# Product Change Notification

PCN20-10 – KSC1 Packaging change

KSC1 versions packaging change.

Current carrier tape	New carrier tape
<b>G Terminations</b>

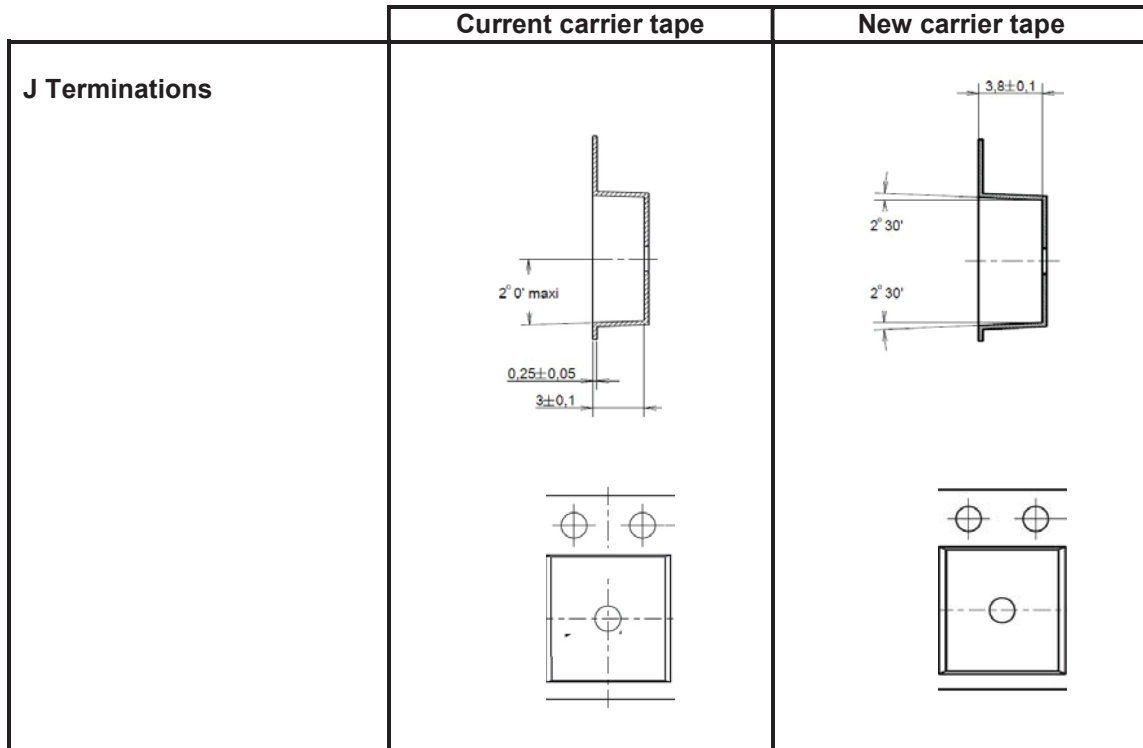
Replacement of the carrier tapes of KSC1 series for G & J versions.  
Standardization with KSC2 & KSC3 series

- 3.1 Impact of Change:
- No change in the switch itself
  - No change of the reels
  - No change of the width of the carrier tapes
  - No change of the cover tape
  - No changes of quantities per reel
  - Only the pockets of the carrier tapes are concerned: Depths are more important.
